**Economic and Social Council**Distr.: General
22 September 2015

Economic Commission for Europe**Inland Transport Committee****World Forum for Harmonization of Vehicle Regulations****Working Party on Passive Safety****Fifty-eighth session**

Regulation No. 16 (Safety-belts)**Proposal for Supplement 7 to the 06 series of amendments to Regulation No. 16 (Safety-belts)****Submitted by the expert from the Netherlands***

Figure 2
Installation of fixture onto vehicle seat
(see paragraph 2.6.1.)

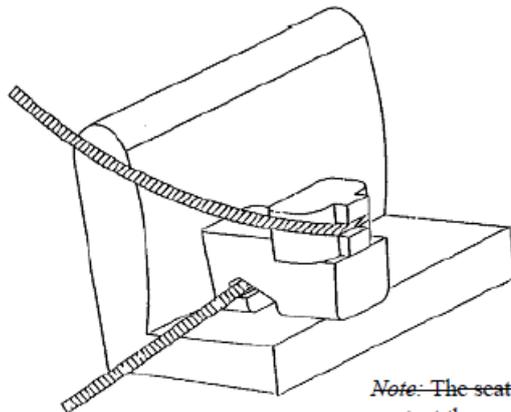
~~Note: The seat belt webbing shall contact the curved edge on both sides of the fixture~~

3. Annex 17, Appendix 1, paragraph 3.2.: So far the test requirements for the belt path are in paragraph 3.2. and Figures 2 and 3. Moreover, the current text could lead to misinterpretation. Accordingly, with the current proposal all test requirements are now concentrated in paragraph 3.2. and most notably what is meant "shall contact" is clarified more precisely.

- "3.2. The lap portion of the belt shall touch the fixture on both sides at the rear of the lap belt path (see Figure 3). **The seat belt webbing shall contact the curved edge on both sides of the fixture over at least [50 per cent] of its width.**
